PLANNING APPLICATION PLN-20-0180

11 GAY STREET, LONGFORD

PROPOSED STORAGE SHEDS AT 11 GAY ST. LONGFORD

Additional Information Required for Planning Application PLN-20-0180- Storage Facility (vary all setbacks; within 50m of Railway; parking forward of building line) at 11 Gay Street, Longford

SITE PLAN
 1:200 @A2

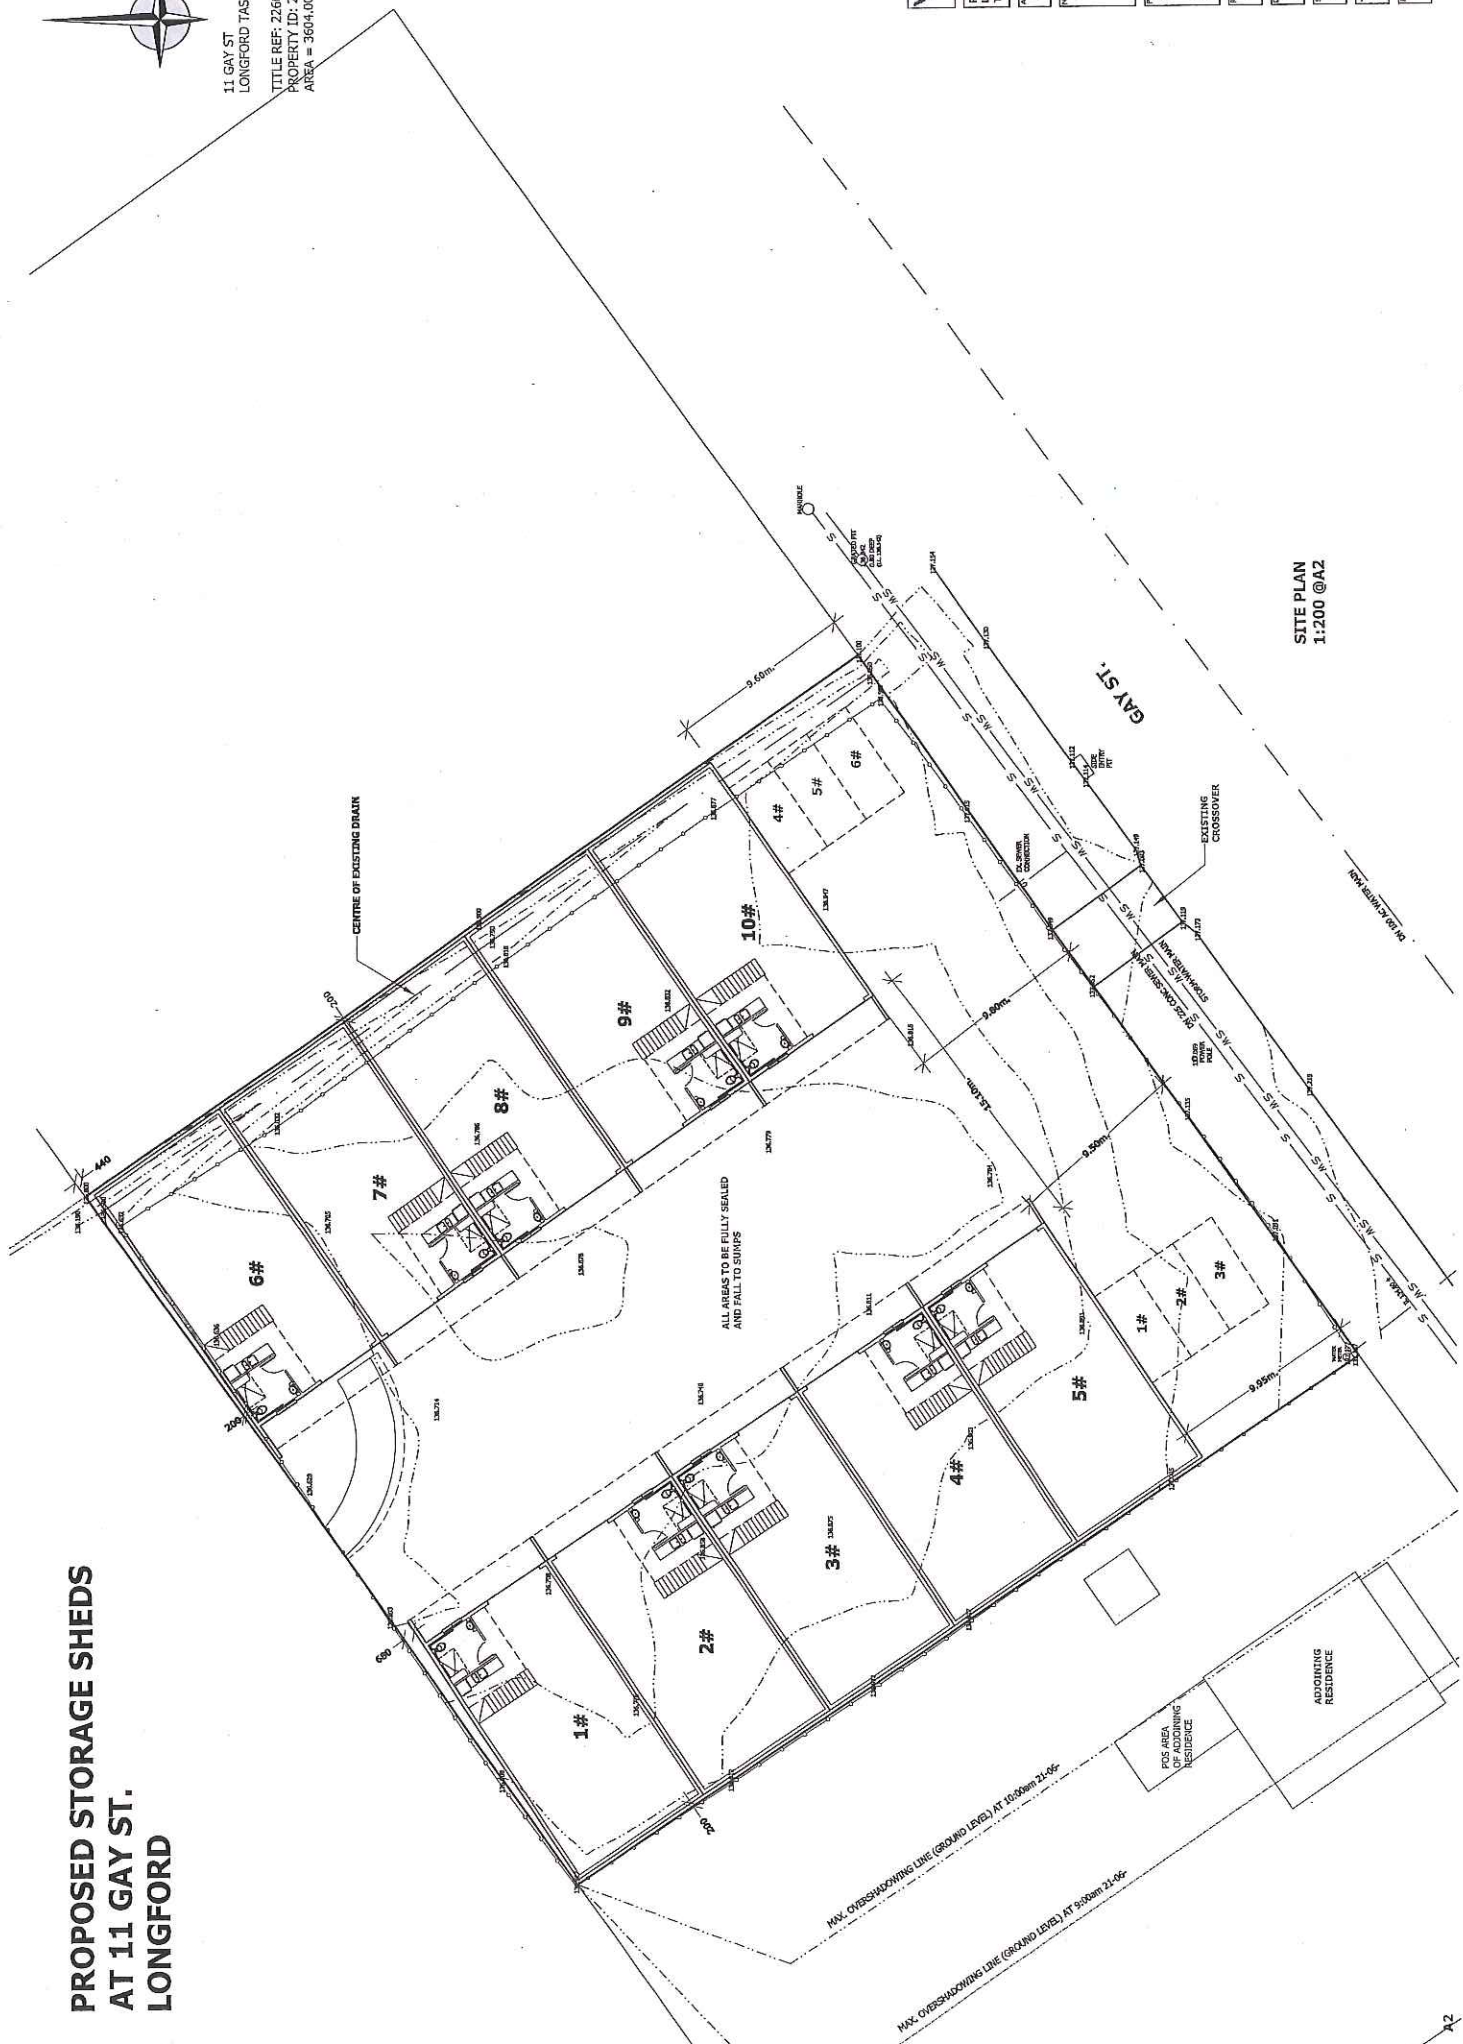
A review of the available information appears to show that the setback distance was measured from the railway track, rather than the boundary line. As a result, TasRail estimates that the proposed setback from the shed to the rail boundary is therefore only about 0.2 metres (confirmed by the letter from Wilkin Design dated 6 August 2020 – reference A3.2 building setback which states rear setback is 200mm = non-compliant.

- the minimum setback distance from the boundary shared with the State Rail Network be increased, and we suggest to 3 metres consistent with the Council Planning Scheme.
- any Permit or Approval issued by the Council note that stormwater and/or other run-off is not permitted to be discharged into the rail corridor or rail drainage system.
- The attached TasRail Standard Notes be included with any Permit or Approval issued by Council

1. **Shade:** I do not agree that the shading as per the proposal is correct, in the proposal it states that my residence is 9500mm away from the proposed structure, but when I measured from my residence to the boundary fence it is 8300mm plus the 200mm from the boundary it would be 8500, not the proposed 9500mm.

Also I don't think that it would be acceptable for my residence to be 90% covered in shade at 9.00am in the morning. But I believe that it would reduce the natural light coming into my eastern side of the house all day, not shade but light, also this would increase my electricity costs due to lighting and heating. The shade would be coming from the higher point which is 5353 not the low side of 4500.

FIRST FLOOR PLAN
1:100

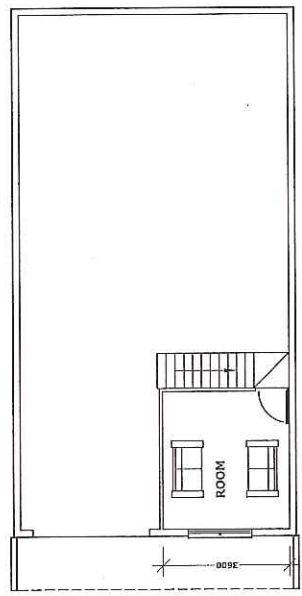
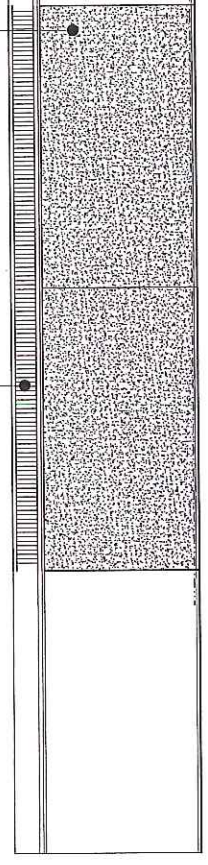
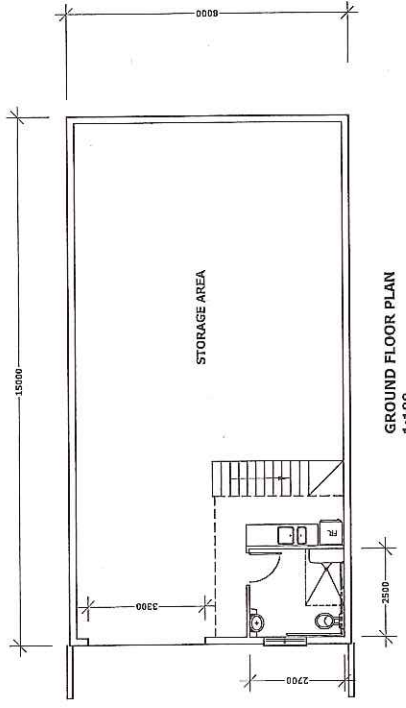
3. **Mezzanine floors:** I don't understand why there are toilets and showers and a kitchenette and lounge area on each of the garage units, this to me would allow people to stay/live in these garages, as stated these are for storage but I can't help feel that they could be used as accommodation unknown to the council??
